**ISSUE:** Certificate of Appropriateness for new construction

**APPLICANT:** City of Alexandria and Washington Metropolitan Area Transit Authority (WMATA)

**LOCATION:** Old and Historic Alexandria District  
2500 Potomac Greens Drive (2405, 2501, 3701 Potomac Avenue, 3251 Potomac Avenue [Parcel ID 016.04-01-01], 700 Carpenter Road, 1702 and 1880 Potomac Greens Drive) 2901 Potomac Avenue (2405, 2501, 3701 Potomac Avenue, 3251 Potomac Avenue [Parcel ID 016.04-01-01], 700 Carpenter Road, 1702 and 1880 Potomac Greens Drive)

The BAR has been reviewing this enormous project through an iterative, cumulative process. The applicant has requested approval of the following three items at this hearing. The remaining items will be brought forward on December 18, or whenever they are ready. Item numbers below reference a spreadsheet that the applicant has used at the past several hearings and is included in the linked staff report of October 16, 2019.

WMATA POTOMAC YARD METRORAIL STATION  
ARCHITECTURAL  
BAR SUBMISSION  
DOWNSPOUT AND GUTTER DETAILS - PLATFORM

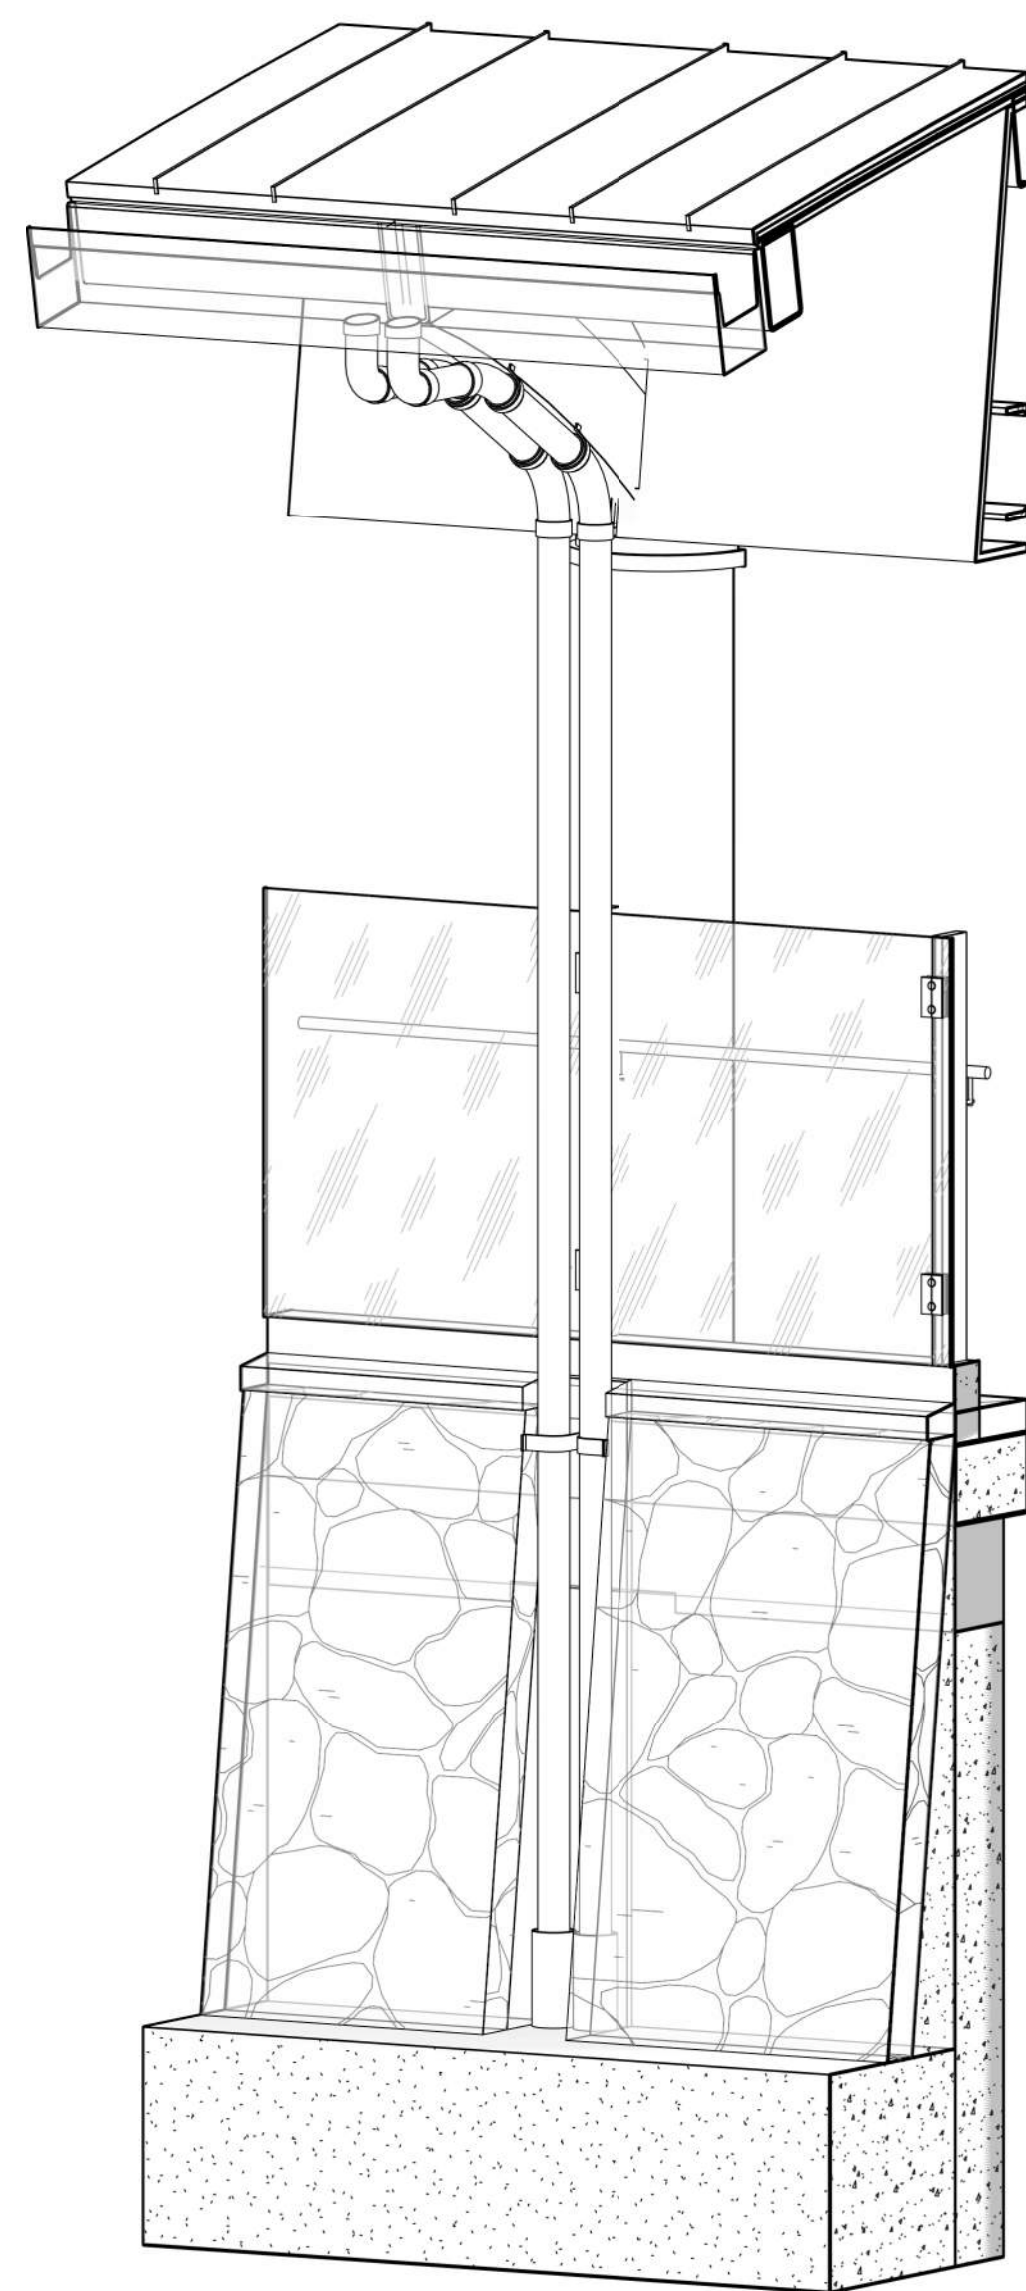
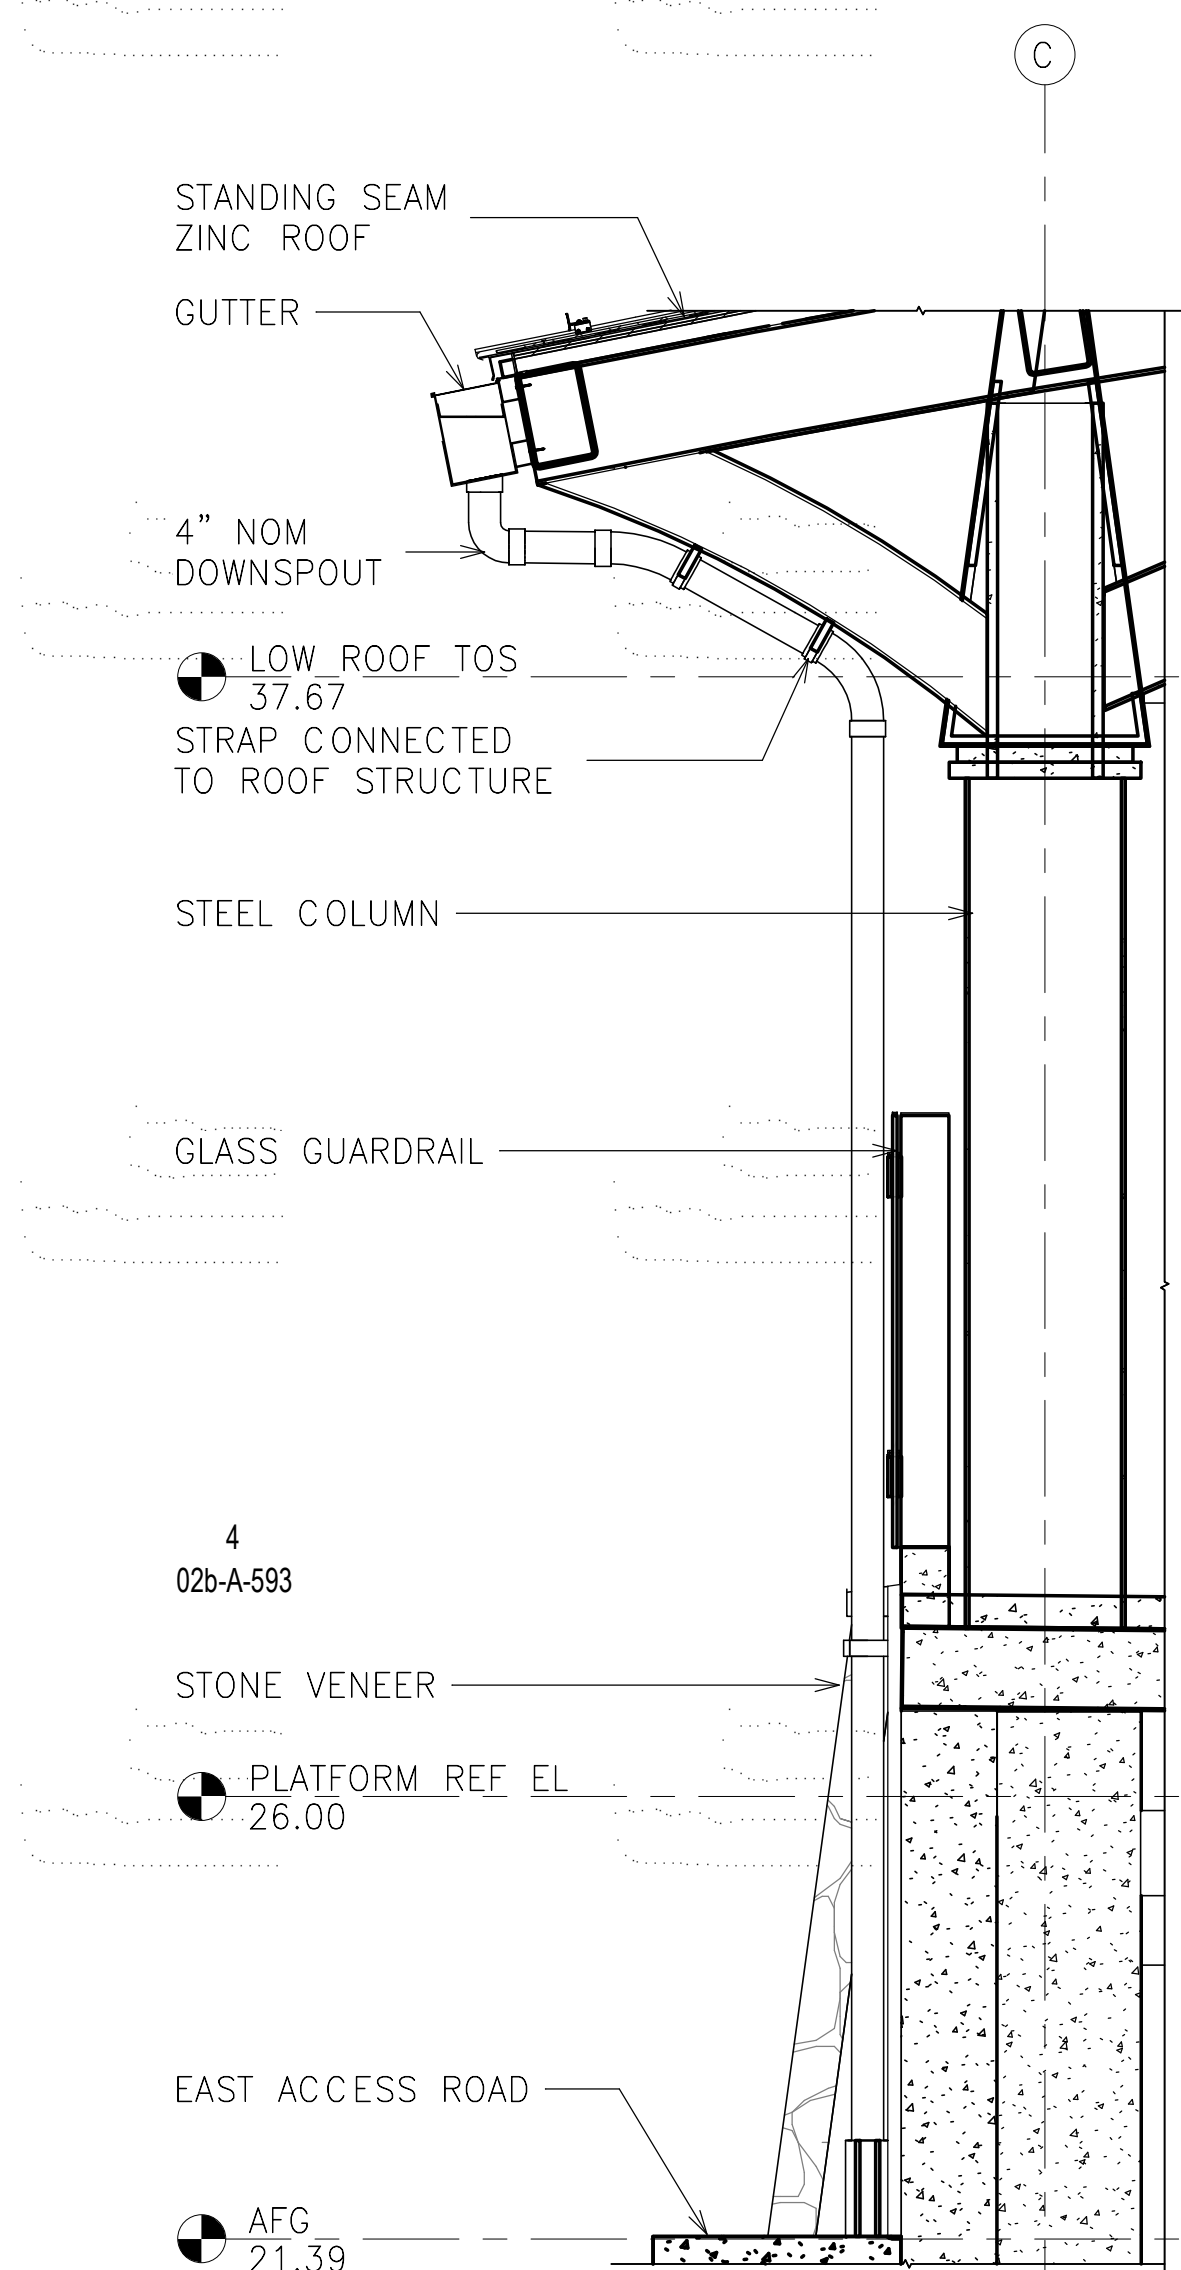
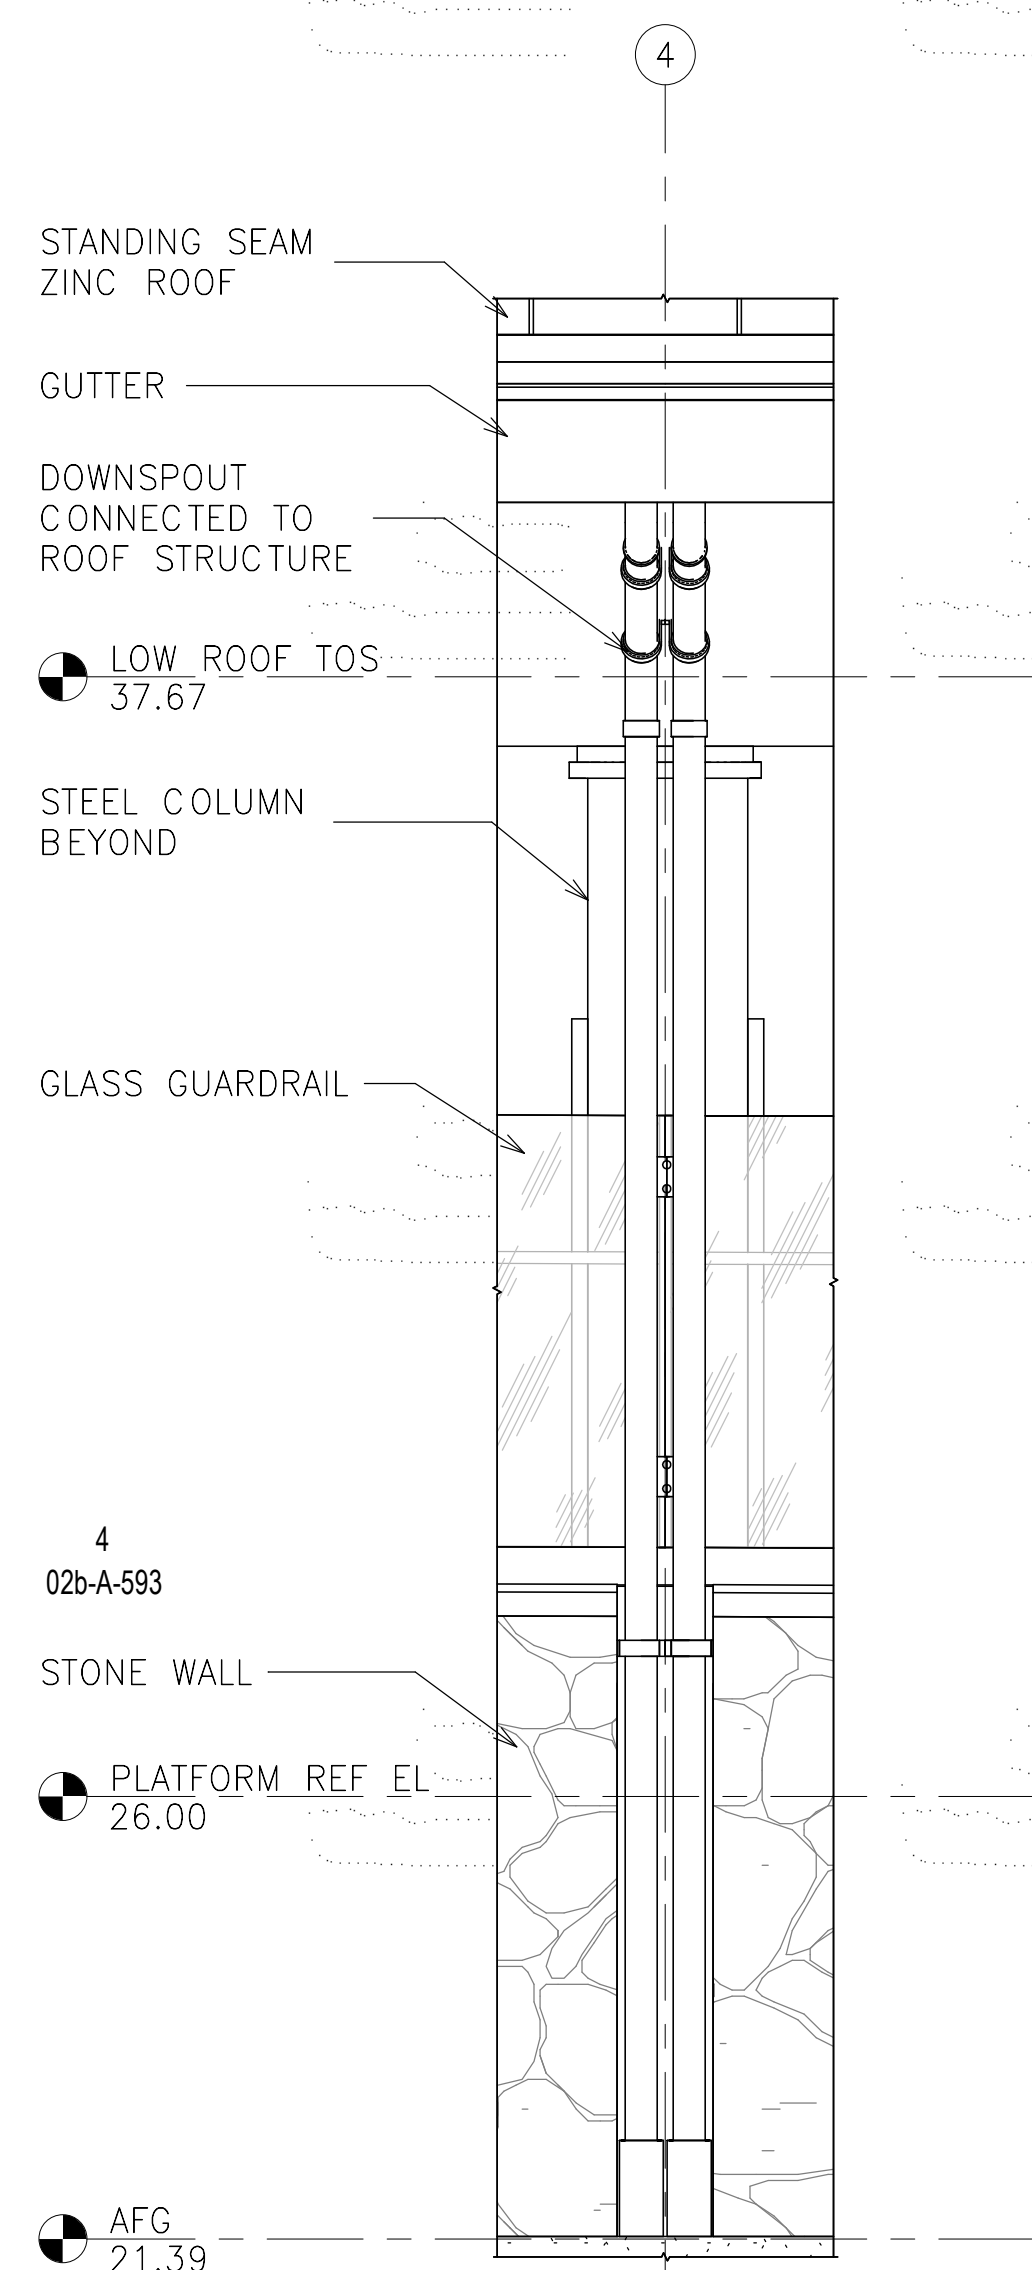
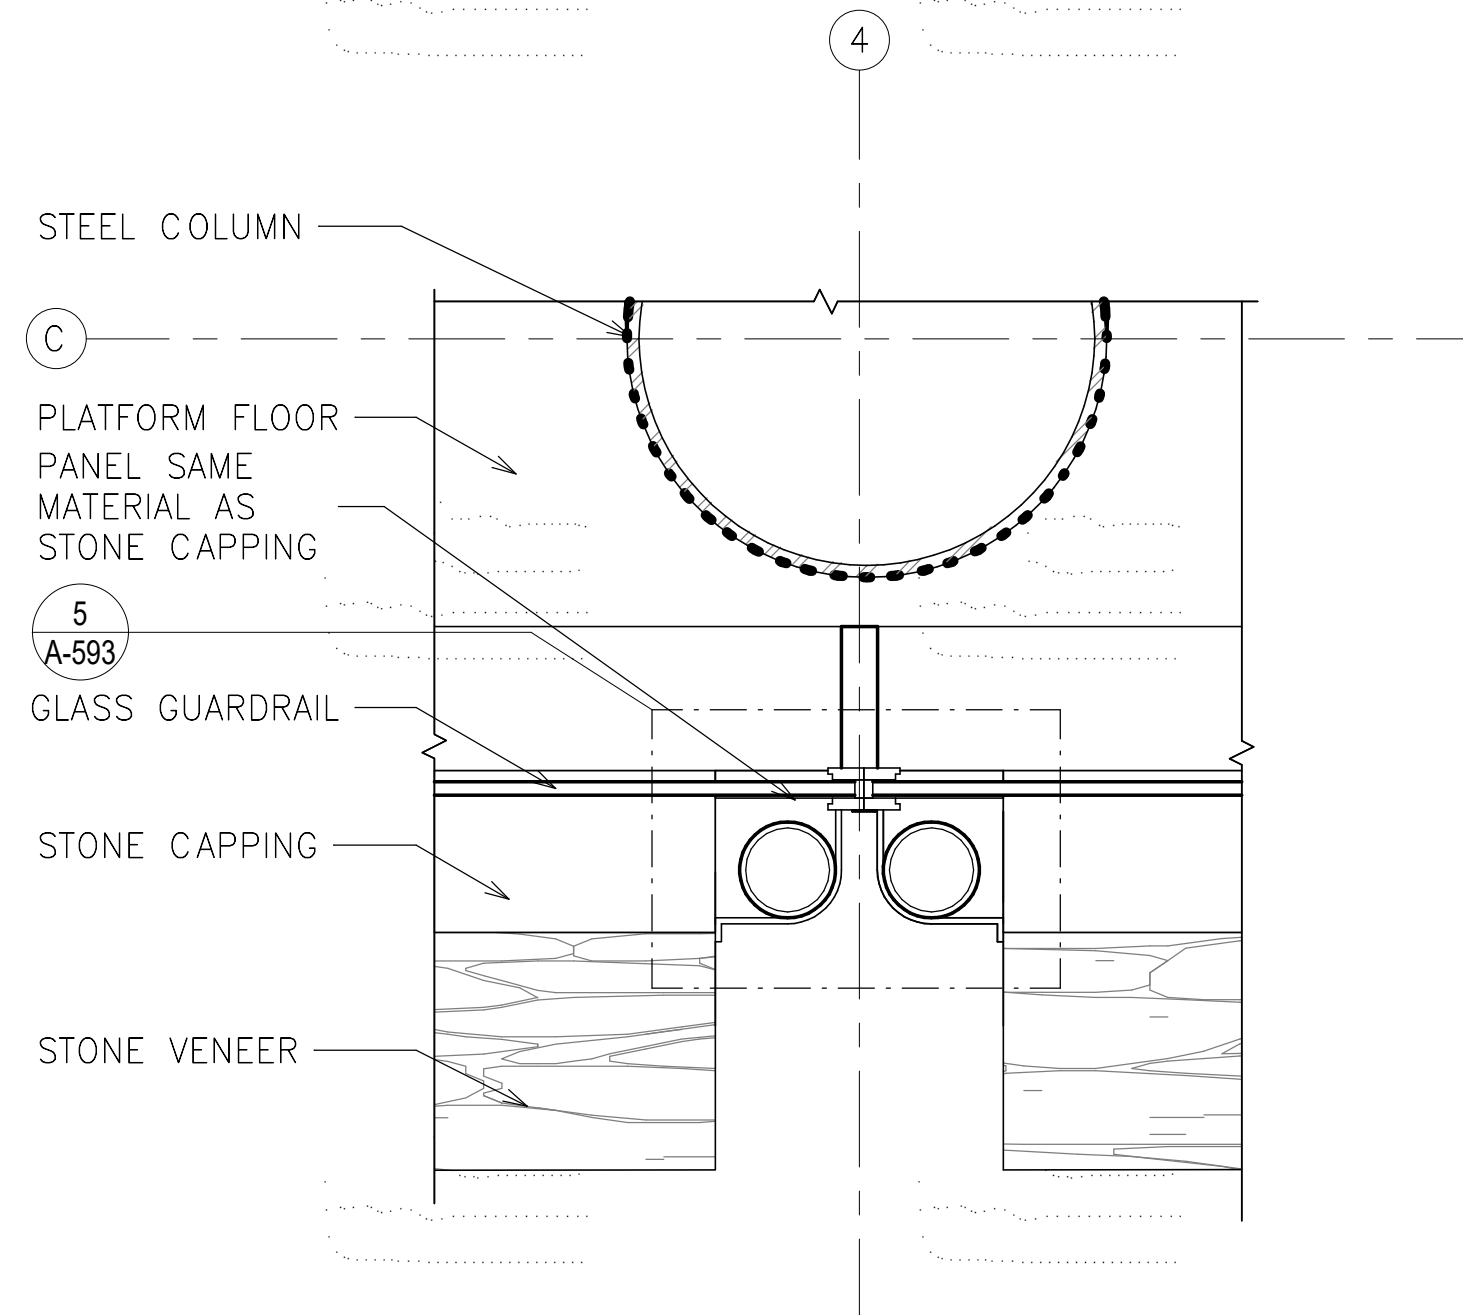
Having demonstrated that it was not possible to conceal the roof drainage system, the applicant has been working with staff to integrate the location of the downspouts into the overall architectural character of the station, as previously directed by the BAR. The downspout pipes have been grouped and aligned with truss extensions, the platform columns and the mezzanine exoskeleton framing. In some locations, this required pairing two downspouts to receive water draining in the gutter from two directions. While the final locations are now generally resolved, the architectural design of the downspouts themselves need additional refinement.

Staff recommends that there be a custom designed leader head at the drop from the gutter that combines both drains into a single rectangular downspout that can closely follow the truss extension and extend down to the rectangular reveal, or notch, in the fieldstone base. The stone base should have a metal cover plate that conceals the cleanout and the transition from the downspout into the underground stormwater system pipes. The design/build team concurs with this recommendation but did not have time to amend the illustrations for the December 4, 2019 hearing. Staff recommends approval of the general location of the downspouts with restudy of their shape and connection details.

1. Staff recommends approval of the downspout locations, the pedestrian bridge design details and of the architectural lighting of the station and pedestrian bridges but will closely follow the final light fixture details through the building permit process to ensure that they comply with the BAR's design intent to minimize glare toward the George Washington Memorial Parkway.
2. Staff recommends restudy of the shape and connection details of the downspouts.
